APPLICATION NO.	FILING DATE	FIRST NAMED INVENTOR	ATTORNEY DOCKET NO.	CONFIRMATION NO.
10/541,281	02/03/2006	Gerrit Jan Nieuwenhuis	MULLE45.001APC	6247
20995 7590 07/11/2007 KNOBBE MARTENS OLSON & BEAR LLP 2040 MAIN STREET FOURTEENTH FLOOR IRVINE, CA 92614			EXAMINER BUI, LUAN KIM	
			ART UNIT 3728	PAPER NUMBER
			NOTIFICATION DATE 07/11/2007	DELIVERY MODE ELECTRONIC

Office Action Summary

10/541,281

FOIL BAG PROVIDED WITH A PUNCHED OPENING AND
INCISIONS

FIG. 1

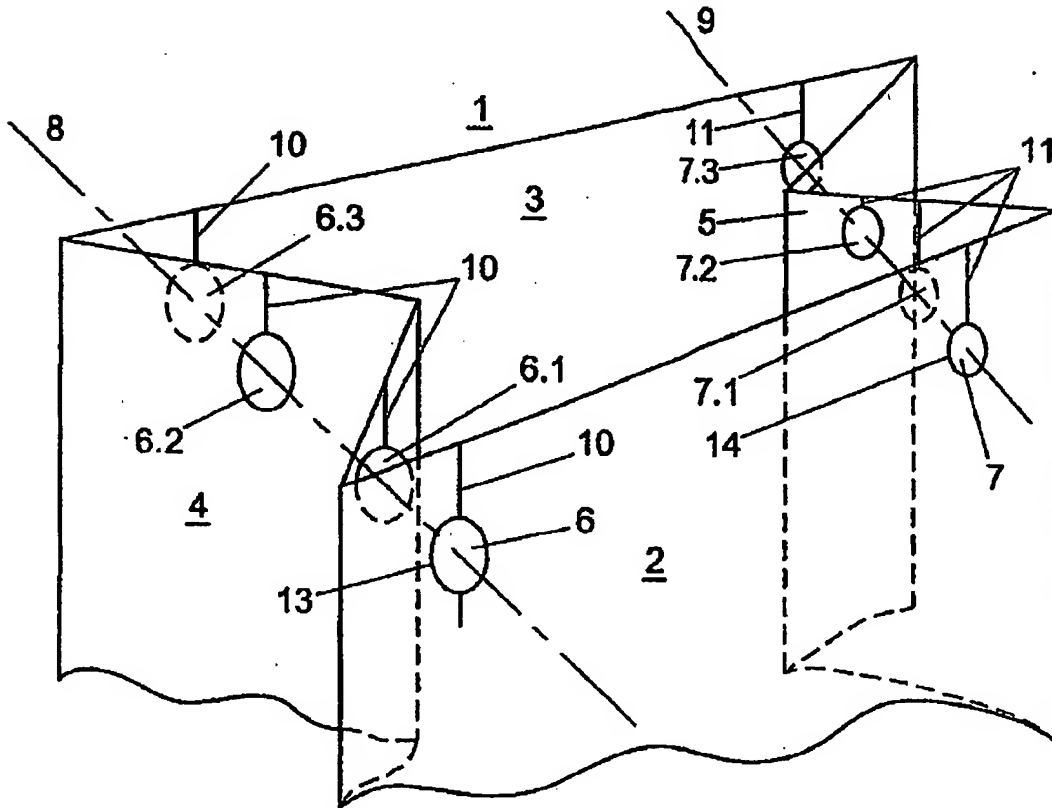
1. The proposed drawing correction and/or the proposed substitute sheets of drawings, filed on 5/21/2007 have been disapproved for entry because drawings introduce new matter. 37 CFR 1.2121 (f) states that no amendment may introduce new matter into the disclosure of an application. The original disclosure does not support the showing of the added features in Figure 1 because the original disclosure states “an incision line 10, 11, 20, 21 may extend e.g. straight from the upper edge of the foil bag to the upper circumferential edge of the opening and then moreover may extend over a length of some millimeters to about 2 centimetres beyond the lower circumferential edge of the opening” but does not indicate that only one of the incision lines may extend beyond the lower circumferential edge of the opening as shown by the Applicant of the incision line 10 in Figure 1. Correction is required.

NOT APPROVED FOR ENTRY. L.R. Bu)
6/25/07

Corrected drawing sheets in compliance with 37 CFR 1.121(d) are required in reply to the Office action to avoid abandonment of the application. Any amended replacement drawing sheet should include all of the figures appearing on the immediate prior version of the sheet, even if only one figure is being amended. The figure or figure number of an amended drawing should not be labeled as “amended.” If a drawing figure is to be canceled, the appropriate figure must be removed from the replacement sheet, and where necessary, the remaining figures must be renumbered and appropriate changes made to the brief description of the several views of the drawings for consistency. Additional replacement sheets may be necessary to show the renumbering of the remaining figures. Each drawing sheet submitted after the filing date of an application must be labeled in the top margin as either “Replacement Sheet” or “New Sheet” pursuant to 37 CFR 1.121(d). If the changes are not accepted by the examiner, the applicant will
